BROWNS FERRY NUCLEAR PLANT (BFN) – UNITS 1, 2, AND 3 - TECHNICAL SPECIFICATIONS (TS) CHANGES TS-431 AND TS-418 – EXTENDED POWER UPRATE (EPU) – RESPONSE TO ROUND 19 REQUEST FOR ADDITIONAL INFORMATION (RAI) (TAC NOS. MD5262, MD5263, AND MD5264)

**TENNESSEE VALLEY AUTHORITY
BROWNS FERRY NUCLEAR PLANT (BFN)
UNITS 1, 2, AND 3**

RESPONSE TO ROUND 19 REQUEST FOR ADDITIONAL INFORMATION (RAI)

Figure EMCB.192/150-1: Illustration of Typical Placement of ASBs

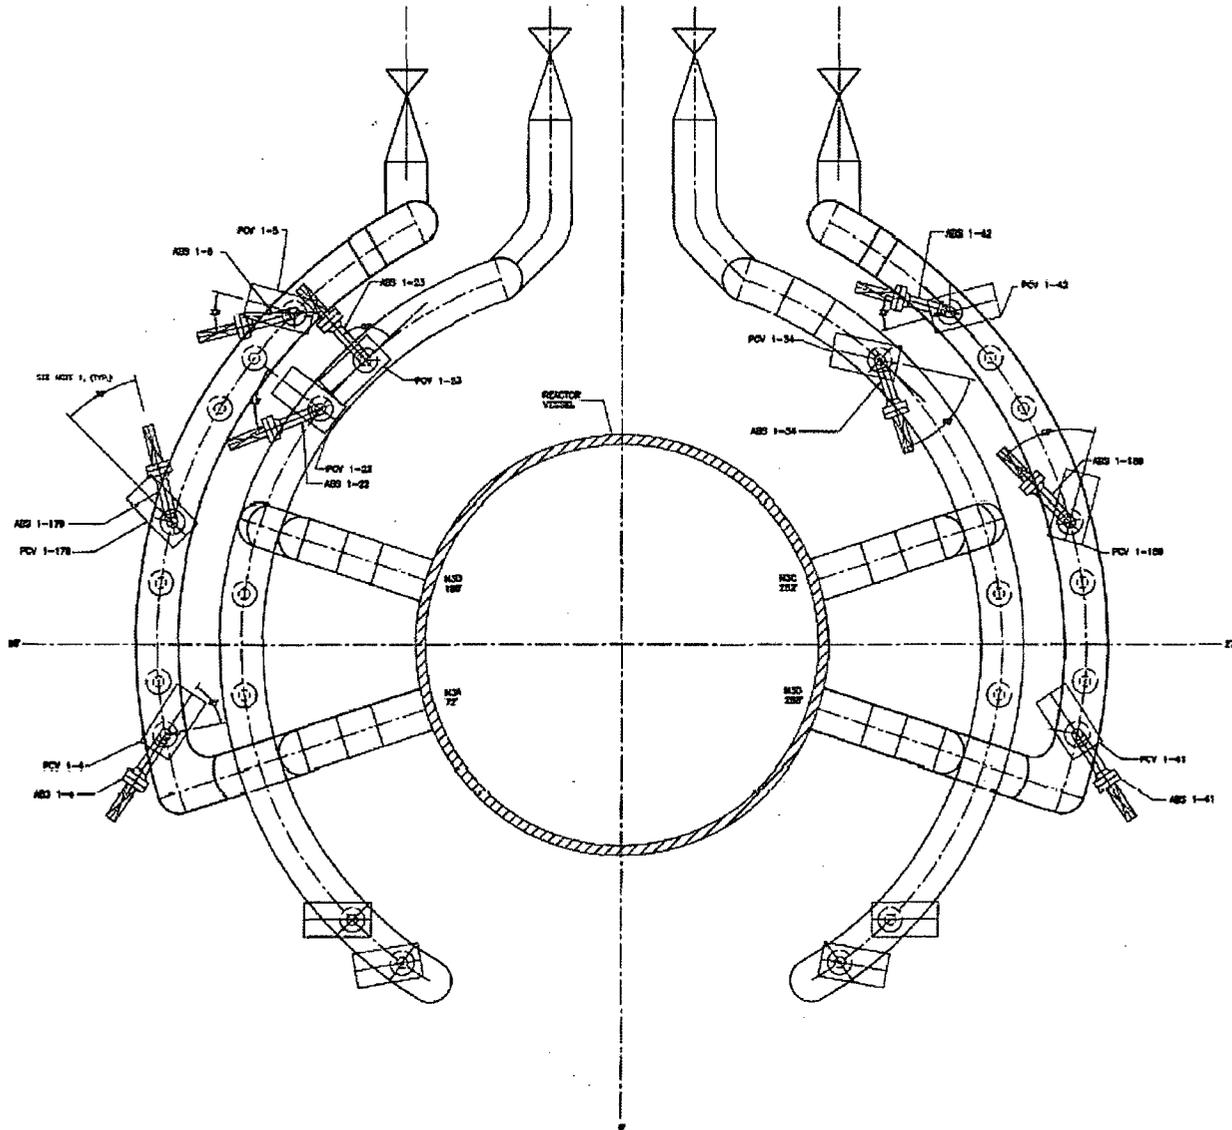
Provide the following information about the planned acoustic side branches (ASBs) for Units 1 and 2, including validation results:

- (b) Provide the lengths of the various ASBs and the acoustic resonance frequencies associated with them;
- (c) Describe the power level(s) at which these (new) acoustic resonances will be excited. If the new resonances are excited, discuss whether it will be locked in;
- (d) Provide the estimated minimum alternating stress ratio of the dryer at flow conditions corresponding to the acoustic resonance of the standpipe-ASB combination; and,
- (e) Address whether the ASBs will be designed by means of the scale-model test, if so provide the corresponding test results for review.

- (a) ASBs will be installed on the nine SRVs that are in the main steam flow path. Four SRVs are located on the MSL dead legs and will not be modified with ASBs. Figure EMC.B.192/150-1 shows a typical placement of ASBs for BFN. This is a preliminary drawing and final orientation of the ASBs on each unit may vary.

Figure EMCB.151-1: PSD comparison of pressure measurements on MSLs

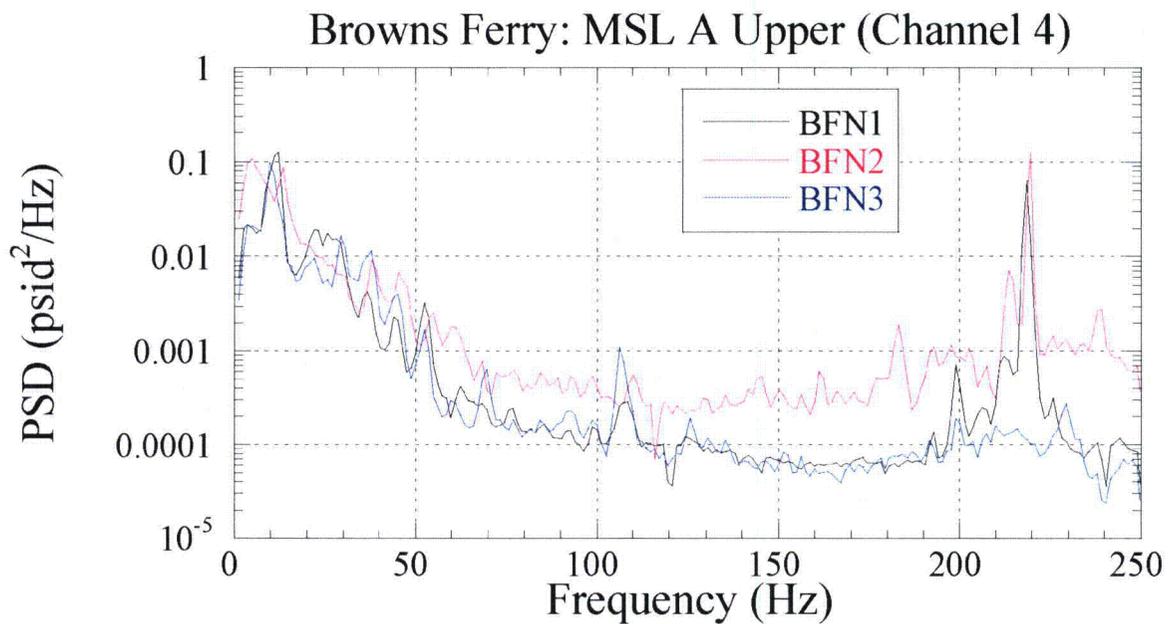
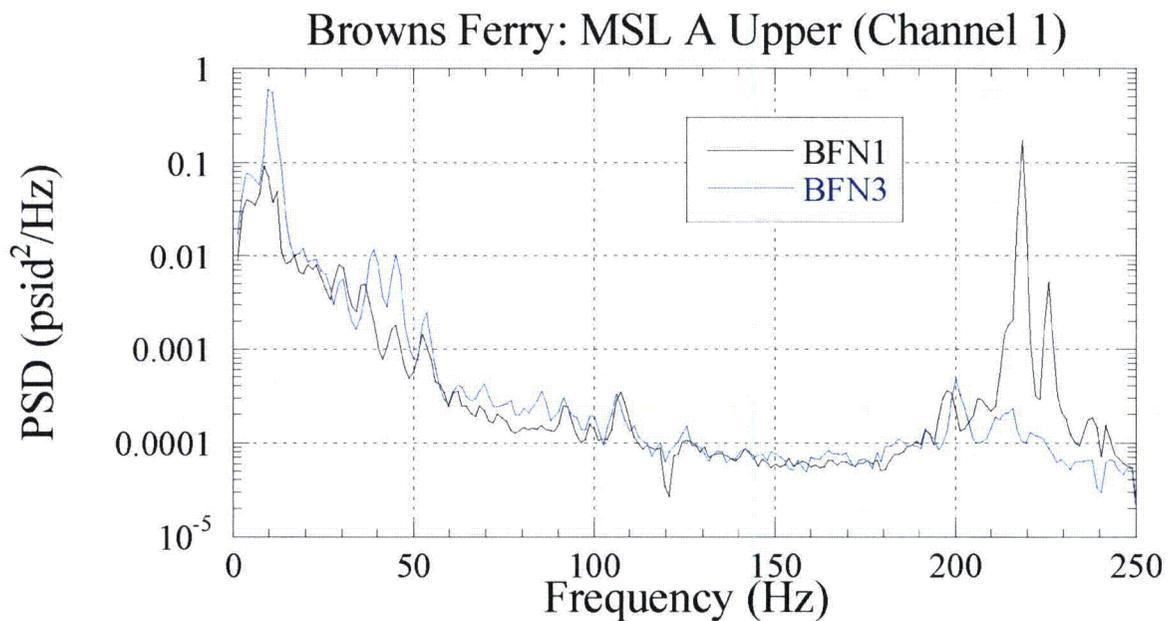
In the response to RAI EMCB.130/97, TVA provides a comparison between the Unit 3 MSL strain gage signals (with acoustic vibration suppressor(AVS)) with the corresponding Unit 1 signals (without AVS), which demonstrate the effectiveness of AVS in suppressing 218 Hz signal. Provide a similar comparison between Unit 3 and Unit 2 MSL signals so that the staff can further evaluate the effectiveness of AVS.

The figures provided in the response to RAI EMCB.130/97 in the June 16, 2008 submittal have been updated with information from Unit 2 in Figures EMCB.151-1 through 5. In these figures, data from the Unit 3 single strain gages at 100 percent power with AVSs installed are compared with data from Unit 1 and Unit 2 single strain gages at 100 percent power at equivalent locations with no AVSs installed. In cases where the Unit 1 or Unit 2 strain gage at the same location was inoperable, the diametrically opposite strain gage was used for comparison. In Channel 1, data was not available for Unit 2. Line noise and reactor recirculation system frequencies were filtered. The 218 Hz signal was not filtered on any unit.
